The Appendix D3 Traffic Impact Assessment dated May 2023 by Amber is grossly incorrect.

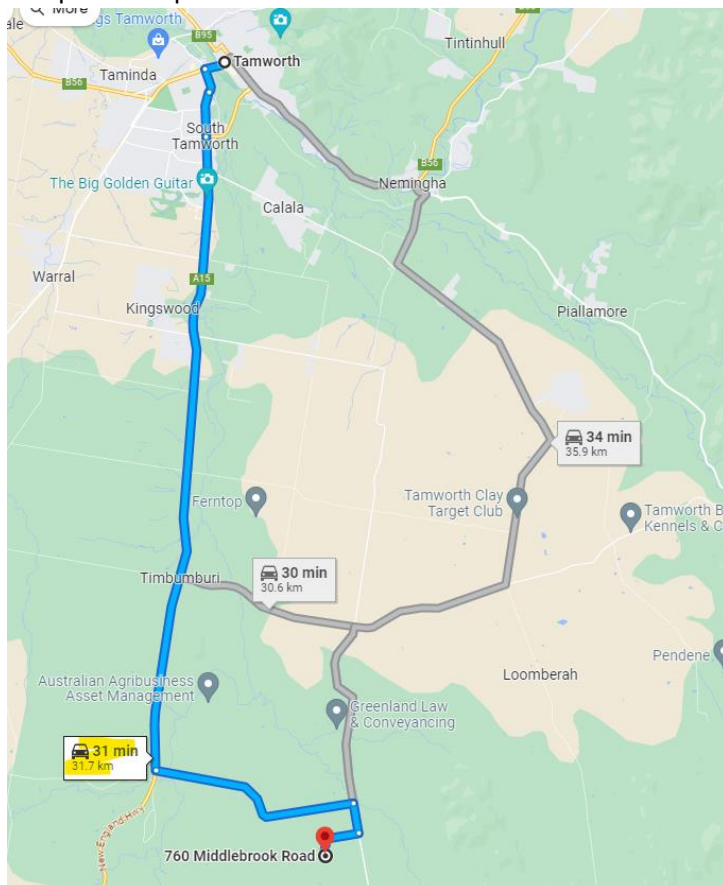
According to Google Maps, a vehicle trip from Tamworth to 760 Middlebrook Road takes 31 minutes and is 31.7km.

Table 3 (above) notes 4 peak hour movements for the shuttle bus. A single shuttler bus cannot complete 4 return trips to Tamworth within 1 hour, so I assume a movement is in one direction, and this totals 2 return trips to Tamworth. Based on a 30 minute trip one way, it is only possible to complete 1 trip within one hour.

1 trip x 40 workers maximum = 40 workers in total transported by the Shuttle Bus in one hour to the project.

400 peak workers arriving to the site in 1 hour – 40 workers transported by the shuttle bus = 360 workers during peak hour still travelling to the project via other means. **The majority of workers would therefore travel via light vehicles.**
